Access Compliance Report Public Rights-of-Way (Curb Ramps)

Main Street: IRVINE_BLVD		Cross Street: BRITTANY_WOODS_DR		Location:	NE
ADA ID: RPRK211014155528	Ramp Type: Type 4 - Parallel	Initial Pass/Fail: Pass	Overall Compliance: No	Severity Score:	0
Codes/Mitigation Info/Possible Solution			Field Measurements/Component Compliance

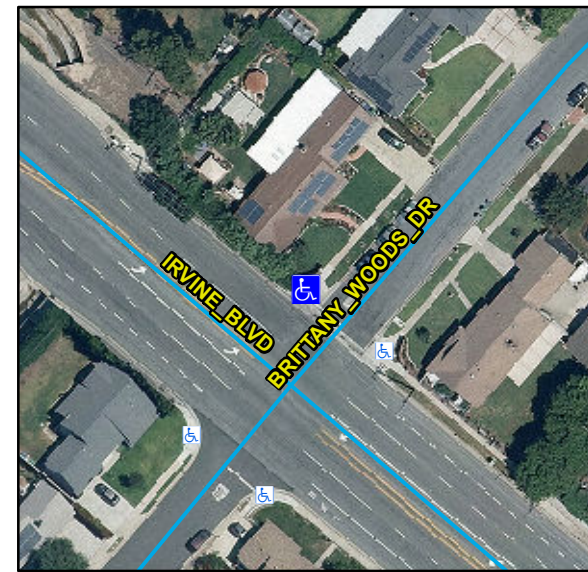
Possible Solutions:

Remove & Replace Curb Ramp With Two New Directional Ramps or Equivalent. Remove & Replace Gutter.

R304.2.2, R204.3, R304.5.3, STD 1115
